STAFF REPORT: PERMIT AMENDMENT

APPLICATION NO.: 5-95-286A

APPLICANT: Esslinger Family Trust

DESCRIPTION OF AMENDMENT: Installation of a 60 inch diameter main storm drain line in the roadways of the mobile home park, a concrete outlet structure at the entrance to the mobile home park, and 5 side canyon drain pipes (Laterals "C" 24 inch, and "E" 24 inch, "F" 12 inch, "G" 18 inch, and "H" 24 inch).

OUTLET STRUCTURE

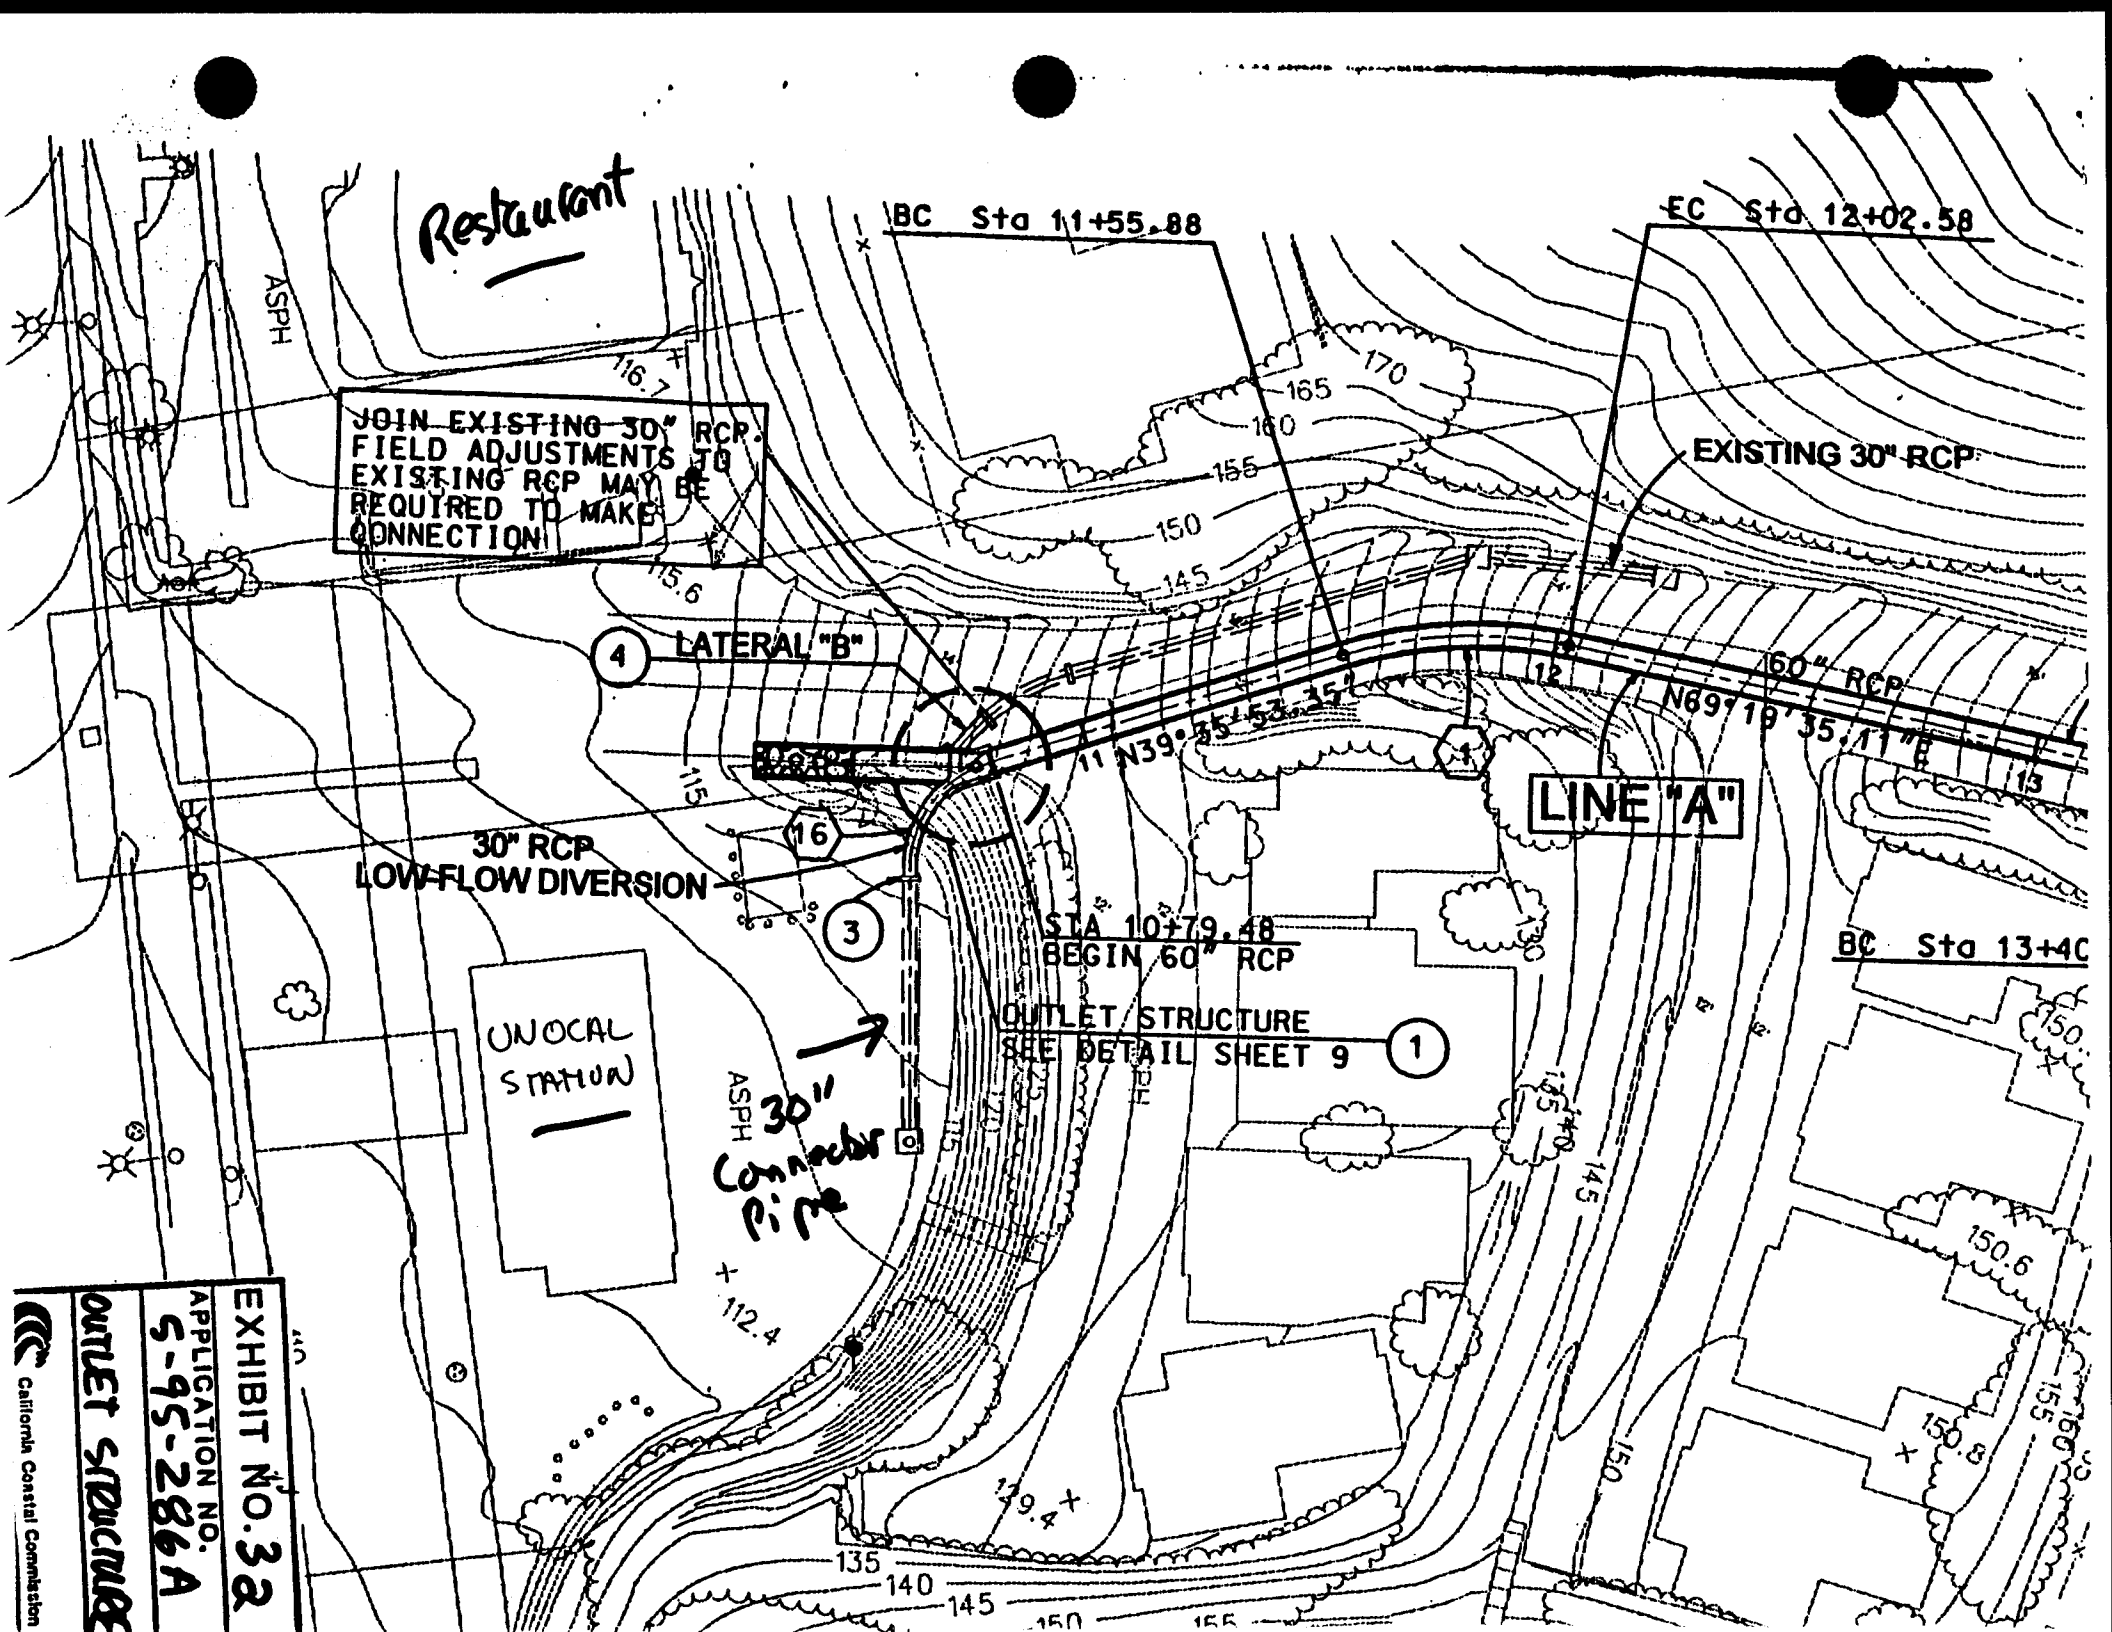
1. It appears that the surface water pattern at the proposed 60" RCP outlet structure has been changed from sheet flow to concentrated flow. This concentration of flow resulted in the increase of both velocity and volume prior to its discharge onto the city street and Pacific Coast Highway.
2. The proposal will divert the current flooding problem from the Mobil Home Park to the State Highway which results in potential liability and increased maintenance responsibility to the State.
3. A detention basin should be considered and provided upstream, to detain any additional runoff to be carried by the proposed 60" RCP. Or to extend the proposed 60" RCP to other proper discharge location without damaging the State Highway.
